COUNCIL ASSESSMENT REPORT

Panel Reference	PPSSWC - 45
DA Number	DA19/0875
LGA	Penrith City Council
Proposed Development	Change of Use of Part of Existing Golf Course to Cemetery Including 27,000 Burial Plots, Chapel and Administration Building, Internal Roads, New Parking and Amended Access from Park Road, Reconfiguration of Golf Course to 9 Holes, New Pool, Gym, Putting & Bowling Greens, and Alterations and Additions to Wallacia Golf Club, Tree Removal and Landscaping, Fencing, Civil and Stormwater Works and new intersection works along Park Road and Subdivision.
Street Address	Wallacia Golf Course 13, 17 & 37 Park Road WALLACIA, NSW 2745
Applicant/Owner	Catholic Cemeteries Board C/- Urbis / Catholic Metropolitan Cemeteries Trust
Date of DA lodgement	11 December 2019
Total number of Submissions Number of Unique Objections	A total of 411 submissions were received including 93 individual submission and including 2 Proformas (325).

SWCPP Ref. No.:	PPSSWC - 45
DA No.:	DA19/0875
PROPOSED DEVELOPMENT:	Change of Use of Part of Existing Golf Course to Cemetery including 27,000 Burial Plots, Chapel and Administration Building, Internal Roads, New Parking and Amended Access from Park Road

Image (below): GRC hydro plan 'Flood Depths' (Source: Applicant)

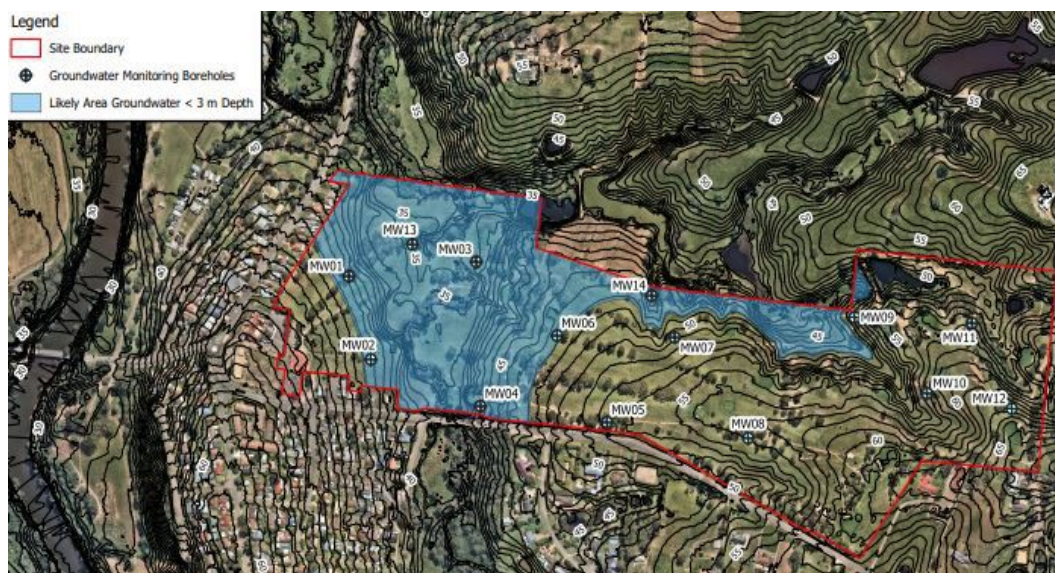
The site is identified on Council's LEP Flood Planning Land map. The area in the vicinity of Jerrys Creek and an area along the northern site boundary are impacted by flooding. The applicant has provided a Flood Impact Assessment prepared by GRC Hydro, dated November 2019, which concludes that the golf clubhouse is located outside of the area impacted by flooding from Jerrys Creek and that proposed floor levels are above the 1% AEP flood extent. The report also provides that no off site impacts will result from the proposed cemetery or the 9-hole golf course works.

Additional information was requested to allow an assessment of the impact of floodwaters on proposed burial plots. A plan was provided which indicates that plots are located outside of the overland flow flooding and also indicates plots clear of areas where the known instance of ground water is <3m or is unsuitable for full body burials.

Figure 13 – Burial Extent and Types

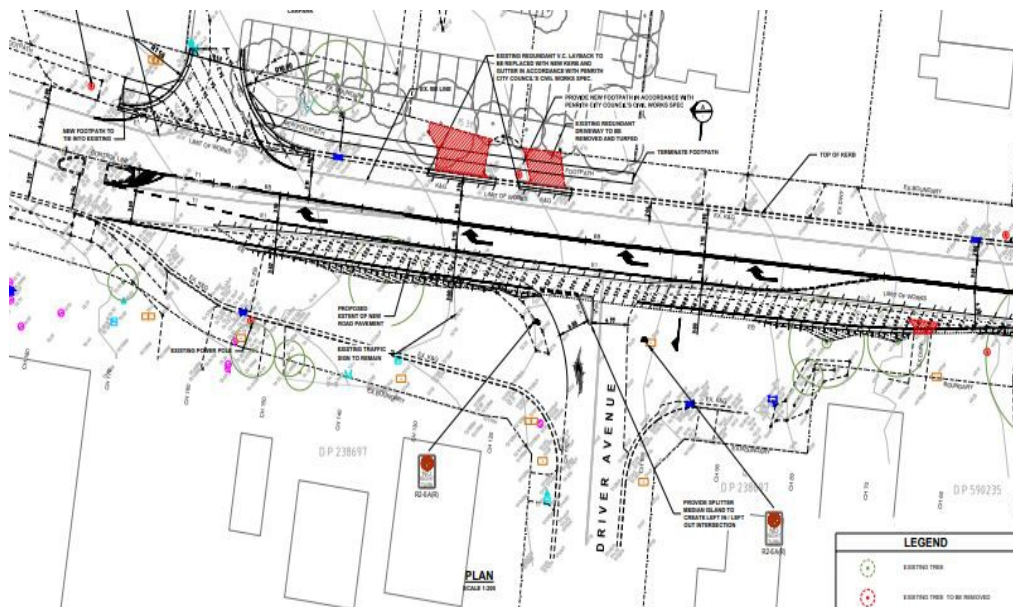
The landscape plan prepared by Florence Jaquet (L101 A, Sheet 03) indicates that lawn burials with high headstones (1500mm max.) placed on concrete beams or as may be constructed as full monuments, are located in the zone adjacent to the eastern most boundary. This may impact on the visual amenity of an existing dwelling at 115 Park Road. In this regard, additional information was requested from the applicant on 27 April 2020, in relation to visual impacts.

It is also recommended that headstones be limited to a maximum of 800mm as the site is identified on Council's LEP maps as being within an area of scenic values (PLEP Scenic and Landscape Values Map) and thus Clause 7.5 Protection of scenic character and landscape values, applies. Refer also to the discussion under the LEP section of this report.
